<b>DOCKETED</b>	
<b>Docket Number:</b>	23-OPT-02
<b>Project Title:</b>	Darden Clean Energy Project
<b>TN #:</b>	258490
<b>Document Title:</b>	CEC Data Request Response Set 5
<b>Description:</b>	Provides the Applicant's fifth response set to data requests received from the CEC. Responses address data requests related to Biological Resources, Hazardous Materials Handling, Project Description, Water Resources, and Worker Safety. The document includes the following appendices to support responses: Appendix A REV 1 DR HAZ-1 Supplemental Soil and Water Sample Results, Appendix B REV 1 DR WS-1 Updated Fire Alarm Site Plan, Appendix C REV 1 DR WS-2 Fire Protection Engineering and UL 9540A Interpretation Report, Appendix D REV 1 DR WS-2 Tesla Megapack 2/XL Hazard Mitigation Analysis, and Appendix E REV 1 DR WS-3 Lithium-ion Battery Electrolyte Safety Data Sheets.
<b>Filer:</b>	Evelyn Langsdale
<b>Organization:</b>	Rincon Consultants

# Darden Clean Energy Project (23-OPT-02)

## CEC Data Request Response Set #5

**Figure 4 Nitrogen Deposition Project Option 3**

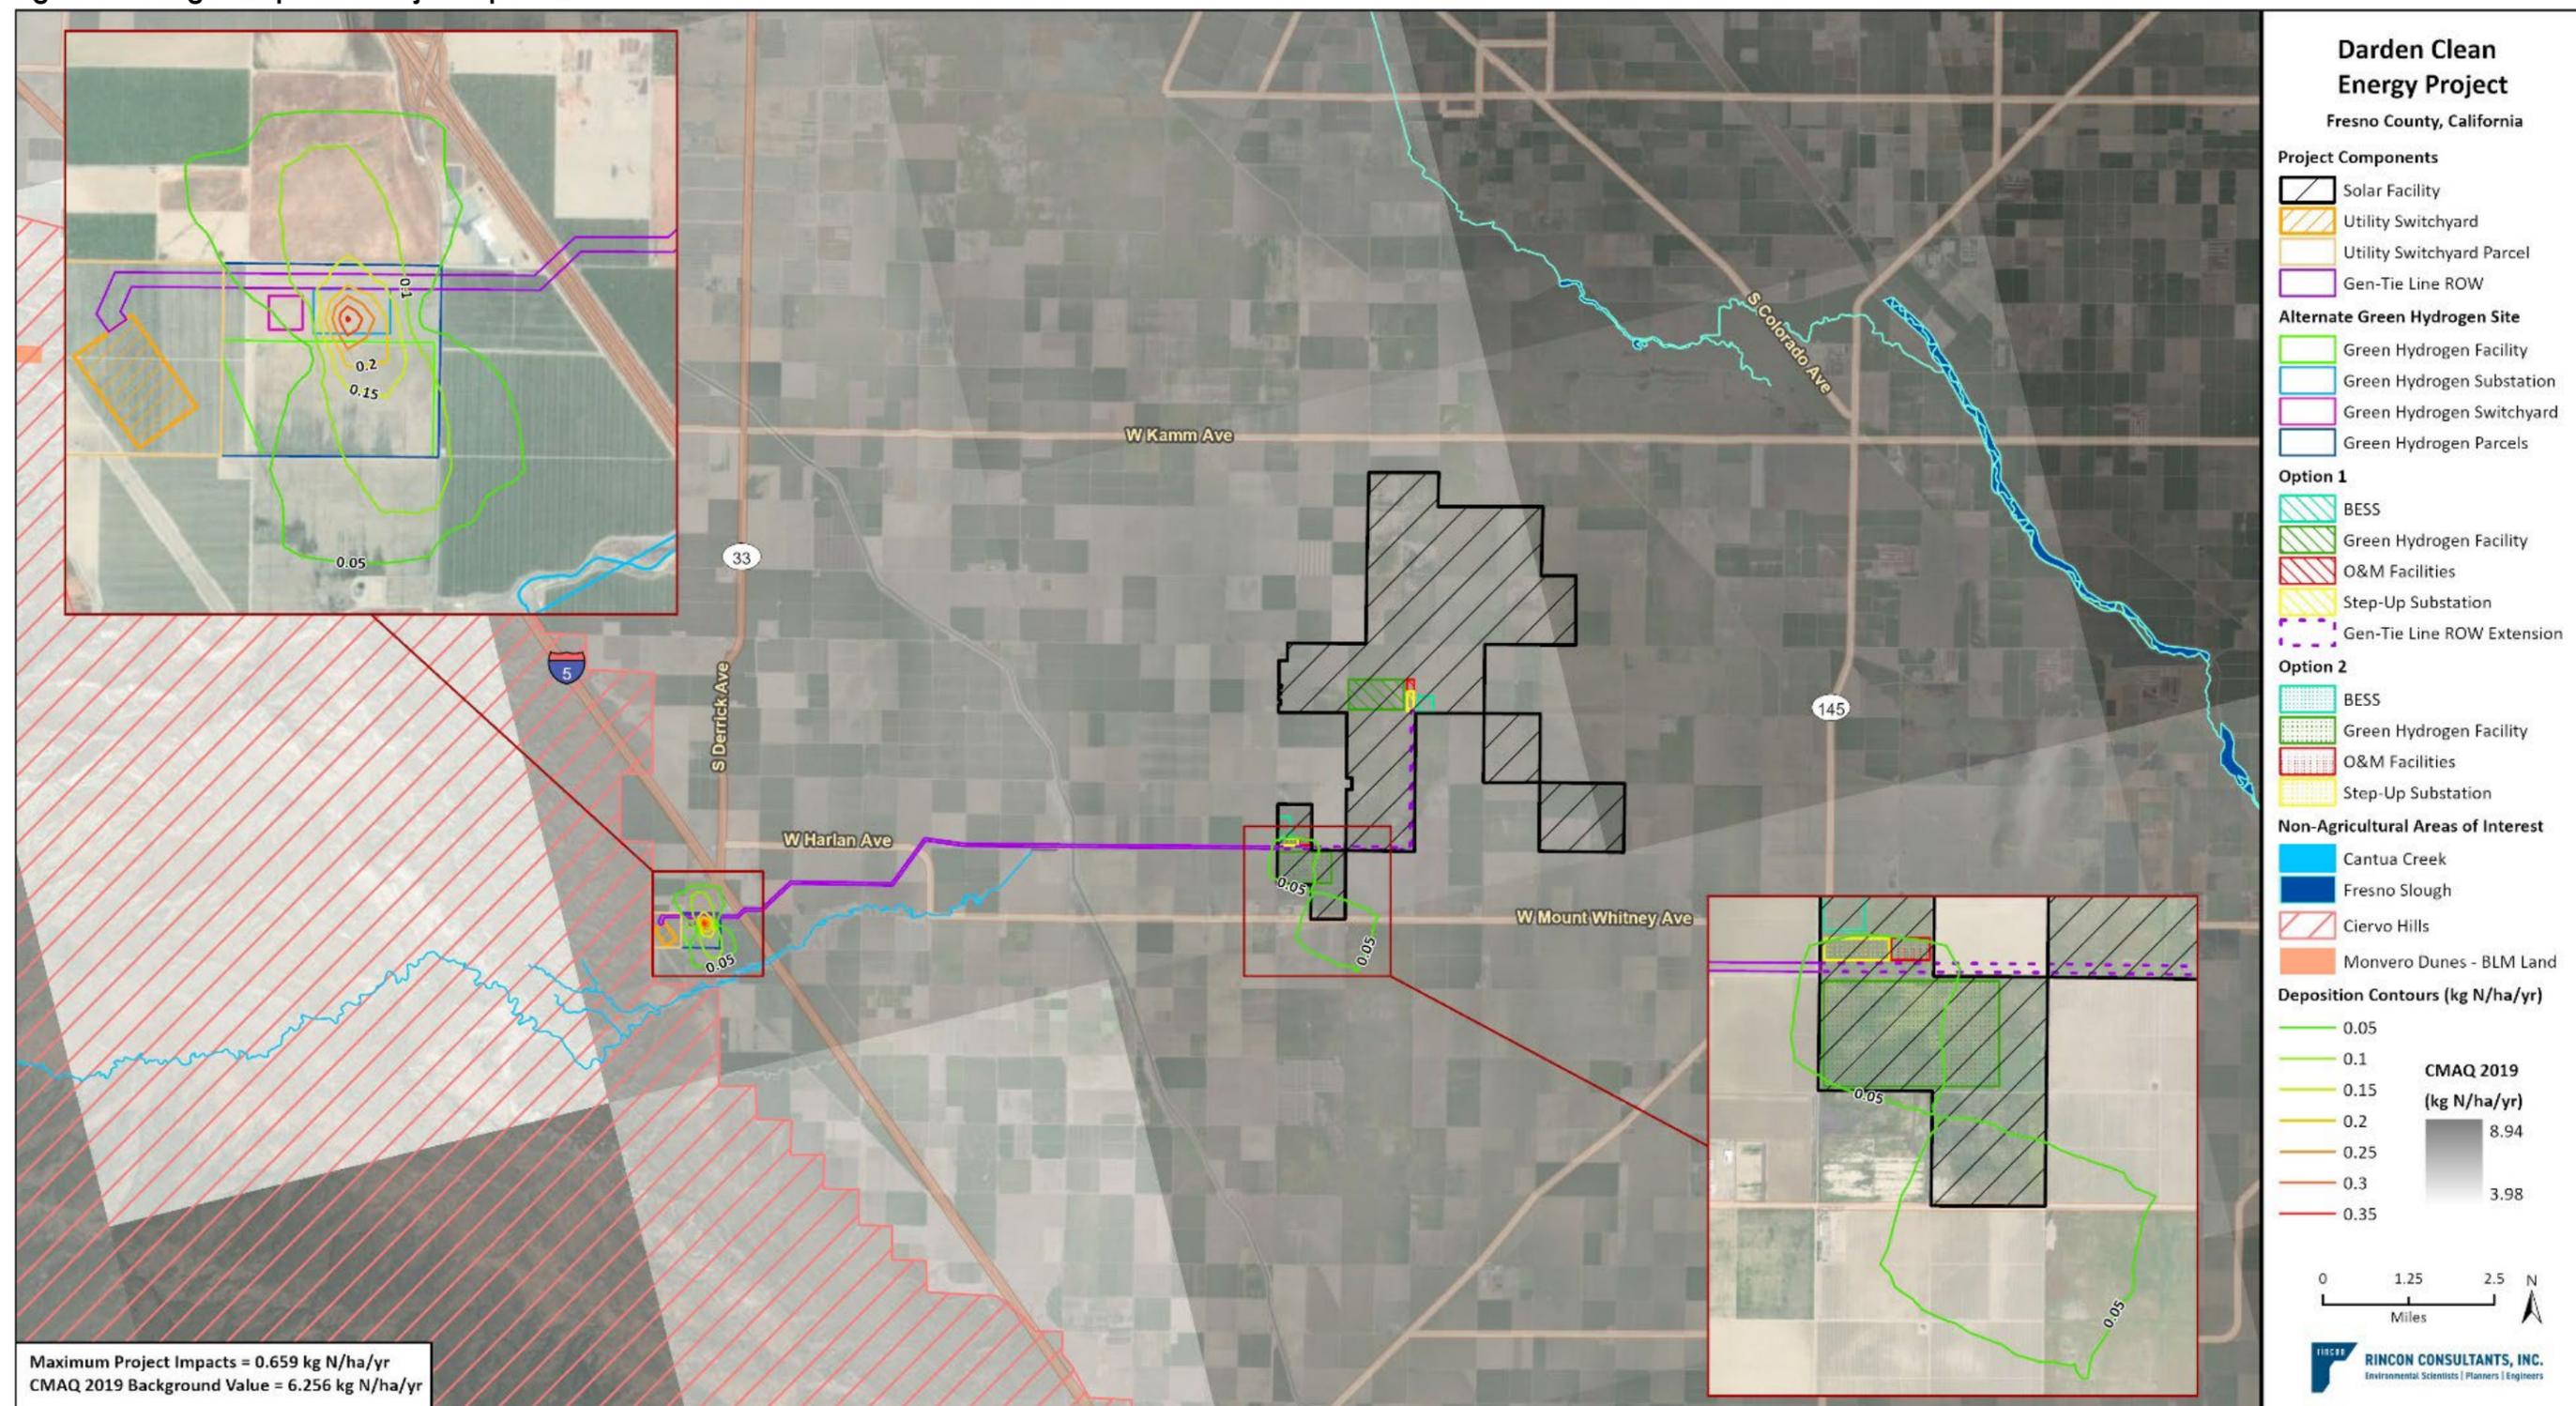
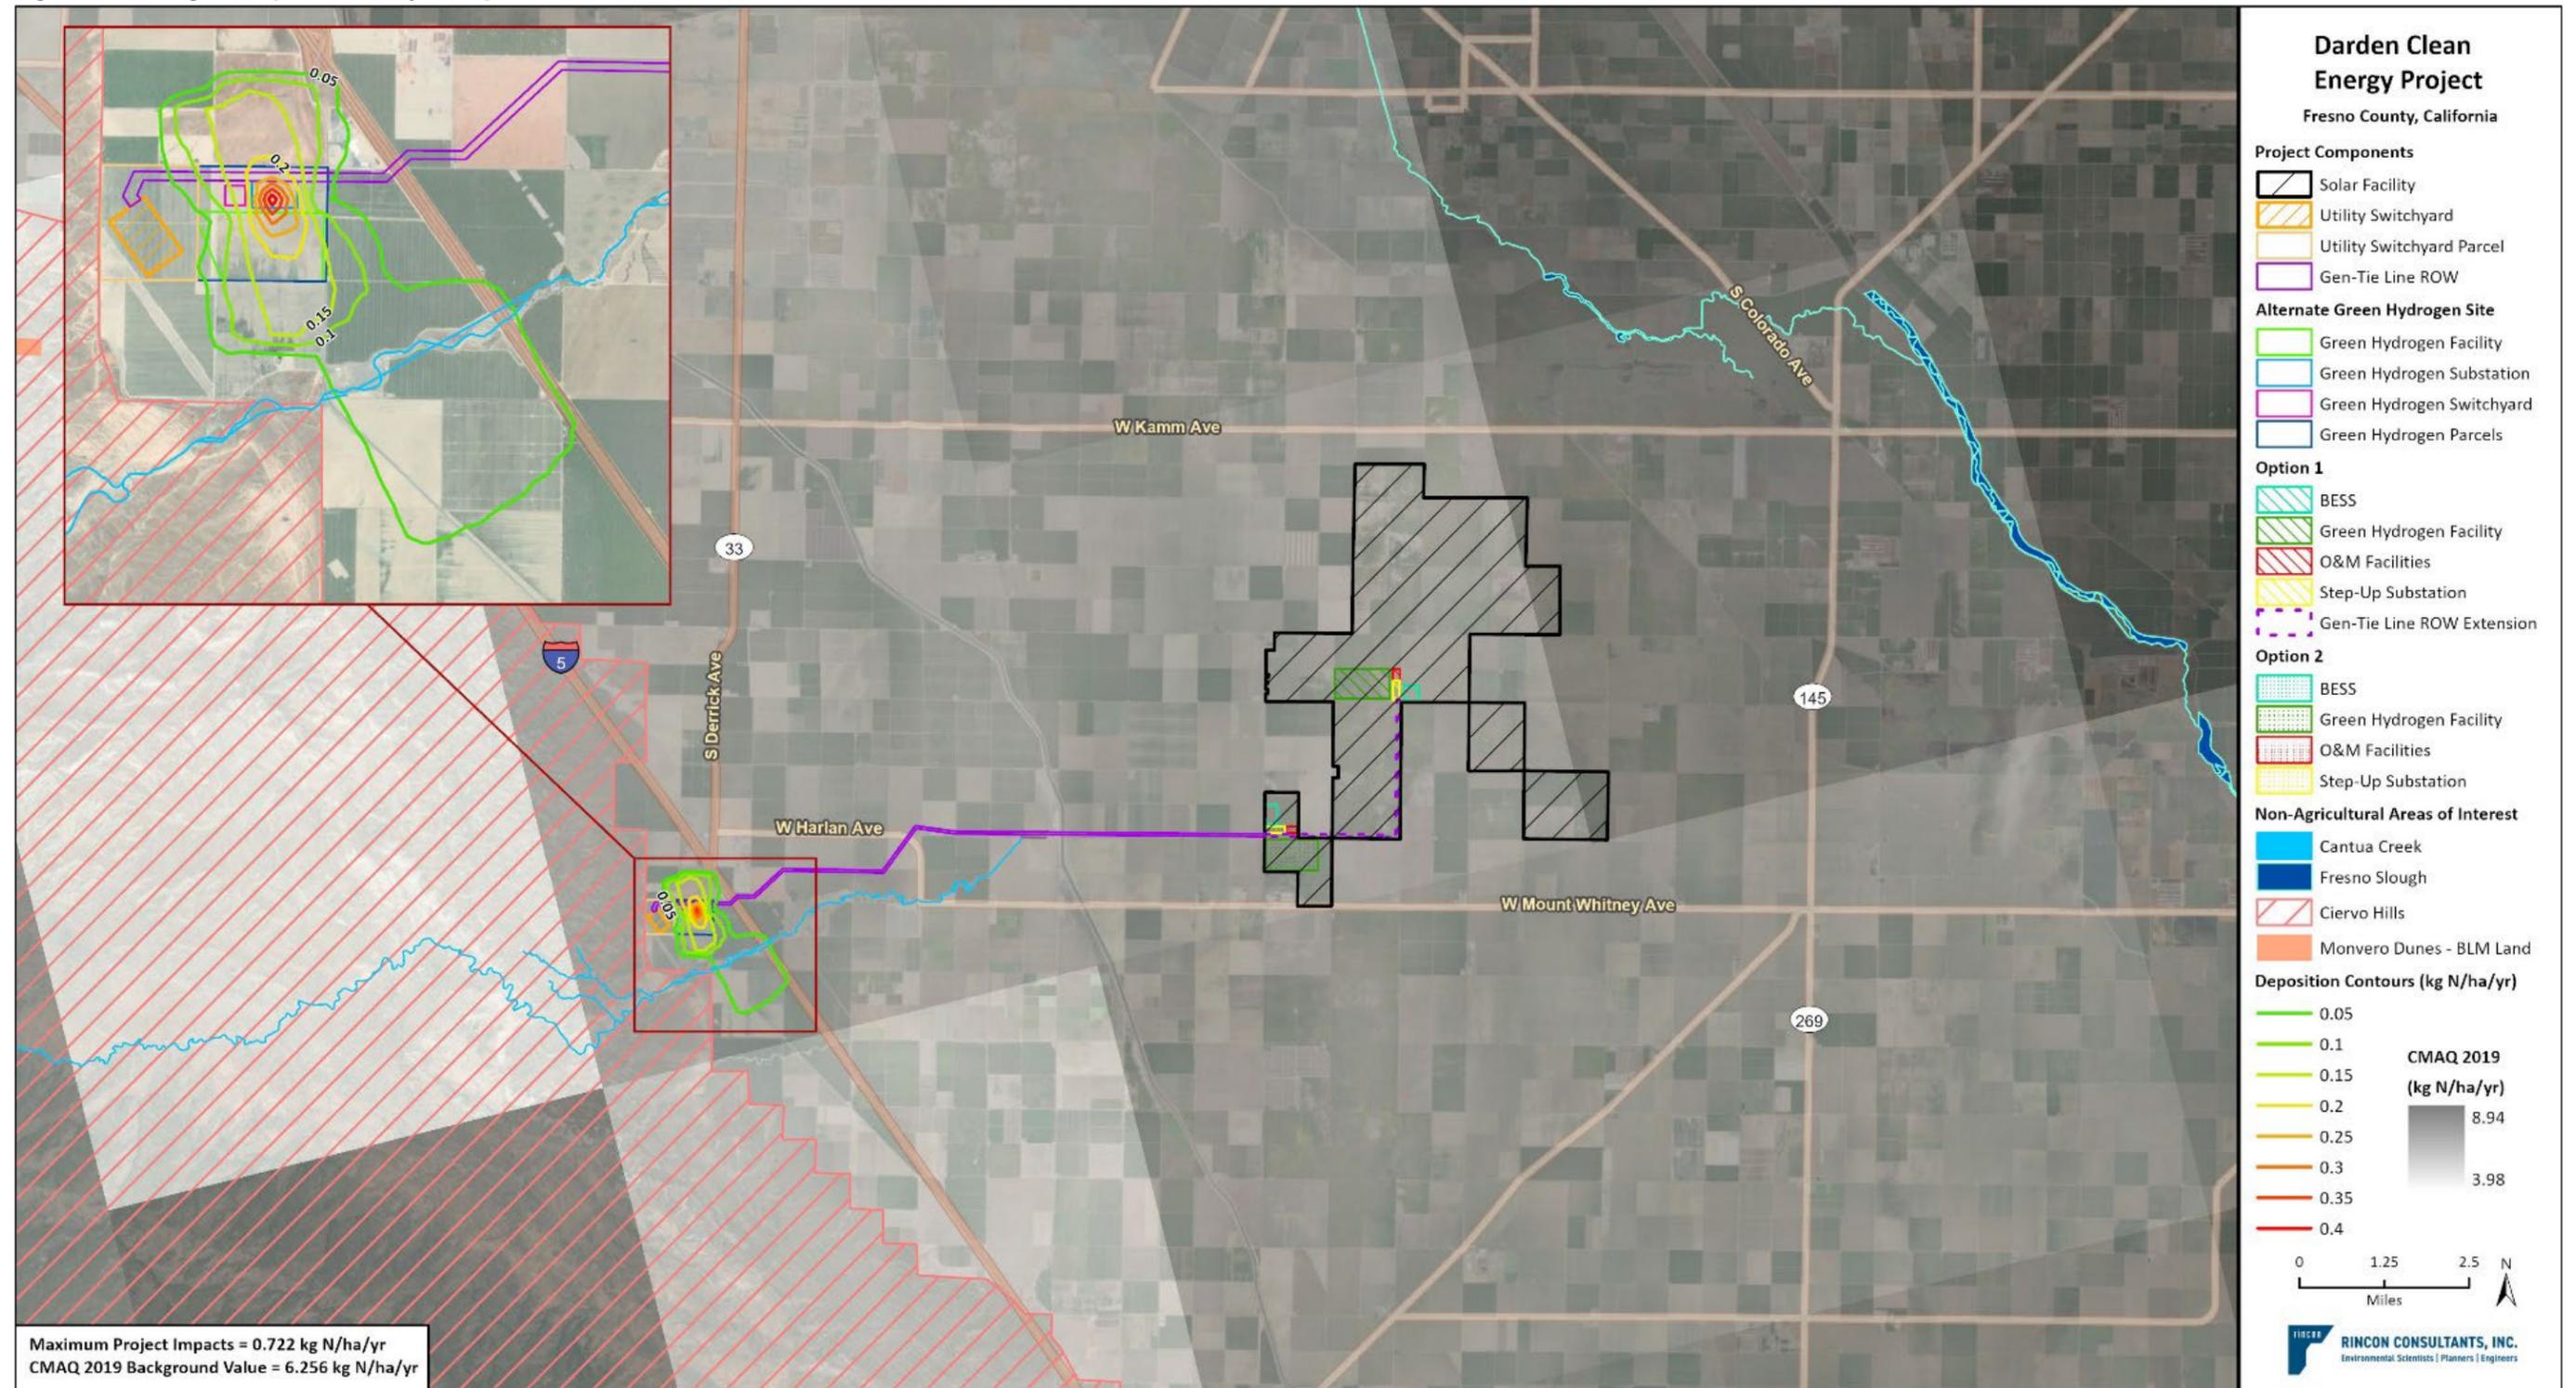
**REV 1 DR BIO-3:** In *CEC Data Request Response Set 4*, in response to staff's DR BIO-20, the applicant provided the maps in Appendix F. However, the maps are not in the correct units. Data was provided in g/m<sup>2</sup>, and the annual values were averaged across 5 years. Please provide revised map(s) for the total annual nitrogen deposition in kilograms of nitrogen per hectare per year (kg N/ha/yr). In adherence with Appendix B (g)(13)(B)(ii), Appendix B (g)(13)(C)(ii) and Appendix B (g)(15)(B)(ii), the maps should display the amount of total annual nitrogen deposition in kg N/ha/yr and should not be averaged across 5 years. Please refer to Great Oaks South Backup Generating Facility (20-SPPE-01) Draft Environmental Impact Report (TN 237875, pages 4.4-13 and 4.4-14), for an example of the expected mapped output, including mapped sensitive habitat, background values, and project features.

**Response:** Revised maps depicting the total annual nitrogen deposition in kilograms of nitrogen per hectare per year are provided in Figure 1 through Figure 4 below. The figures were revised to display the maximum annual nitrogen deposition values, rather than the 5-year average previously presented, which corresponded to a slight increase in annual nitrogen deposition values. The maps include project features, the non-agricultural areas of interest discussed in Appendix F of CEC Data Request Response Set 4, and background values.

The updated nitrogen deposition values presented in Figure 1 through Figure 4 show a maximum annual nitrogen deposition of 0.722 kg/ha/yr compared to the 5-year average of 0.684 kg/ha/yr previously discussed in Appendix F of CEC Data Request Response Set 4. The previous response also compared the modeled nitrogen deposition to average background nitrogen deposition values expected in this region of California (7-9 kg/ha/yr); however, the figures have since been updated with background 2019 CMAQ data (with a maximum of 6.256 kg/ha/yr). The results of the nitrogen deposition model also indicate the average nitrogen deposition rates using the source group "All" conservative approach would be on the order of  $1.0 \times 10^{-5}$  kg/ha/yr in the non-native grassland, dune and freshwater emergent wetland habitats and  $1.0 \times 10^{-4}$  kg/ha/yr along the Cantua Creek aquatic habitat and riparian corridor.

Therefore, the updated figures do not change the conclusions presented in the response to DR BIO-20 or Appendix F in CEC Data Request Response Set 4. The modeled annual nitrogen deposition remains well below the critical loads at sensitive habitats, as discussed in Appendix F of Data Request Response Set 4.

Figure 5 Soil and Groundwater Well Sample Locations

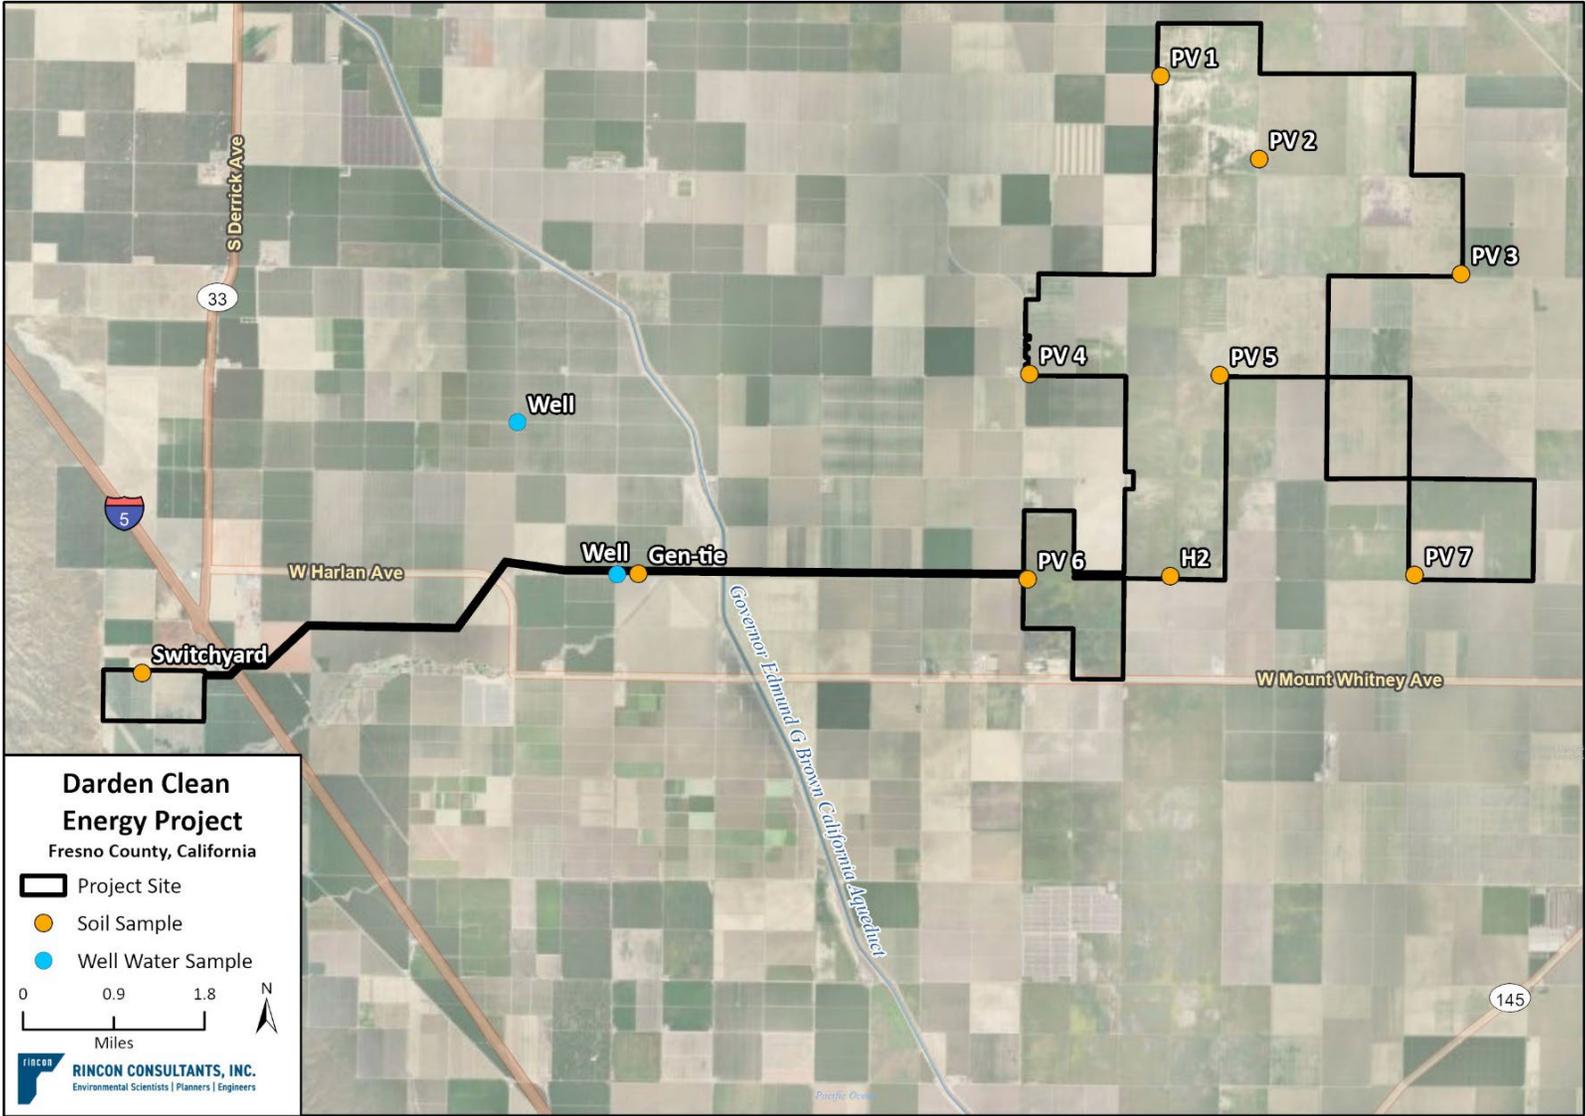
**REV 1 DR HAZ-1:** Staff reviewed the Phase I and Phase II Environmental Site Assessments (ESAs) presented in Appendix F from applicant's CEC Data Response Set 3 in response to staff's DR HAZ-1. Staff notes that these ESAs describe obtaining soil samples at various dates in 2022 and 2023. The soil samples were analyzed for OCP (organochlorine pesticides), lead, and arsenic at 41 locations across the subject property and 10 of those 41 were analyzed for selenium. Although these reports recommended consideration of well-water for dust suppression at the site, well-water or groundwater sampling and analysis data could not be found in any of these reports.

Based on the response to staff's DR HAZ-1, staff needs additional information to assess the potential health hazards posed to workers involved in soil disturbances, trenching, and excavation activities, in addition to evaluating the use of well-water or groundwater for dust suppression. Please prepare and implement a supplemental Sampling and Analysis Plan (SAP) to sample and analyze a representative number of soil samples and well-water samples within the site and the linears (including the proposed hydrogen gas pipeline route) for the herbicide DCPA (Dacthal) and CAM-17 metals per the California Administrative Manual. This SAP should also include analysis of the organochlorine pesticides in the well-water samples and along linears that were not previously sampled.

**Response:** The Applicant collected additional soil samples and well-water samples in July 2024, which were analyzed for the herbicide DCPA (Dacthal) and CAM-17 metals per the California Administrative Manual, as well as organochlorine pesticides. The locations of the soil and groundwater well samples are depicted on Figure 5 below. Using input from the CEC, the Applicant sited the soil sample locations across the Project area to provide representative results across the PV facility, the utility switchyard parcel, the gen-tie corridor, and a hydrogen stub pipeline alternative. Soil samples were collected between zero and six inches below surface and five sub-samples were collected at each sampling location, then sent to the lab for analysis. For consistency, the water samples were collected from the same groundwater wells previously sampled, with one well located in the gen-tie corridor and the other 1.4 miles north of the gen-tie corridor. Irrigation pumps ran for one hour prior to sampling to ensure the collection of an accurate and representative sample of the water table quality. Although these wells have not been identified as the source for construction and operations water, the water samples provide representative data of water quality within the area surrounding the Project.
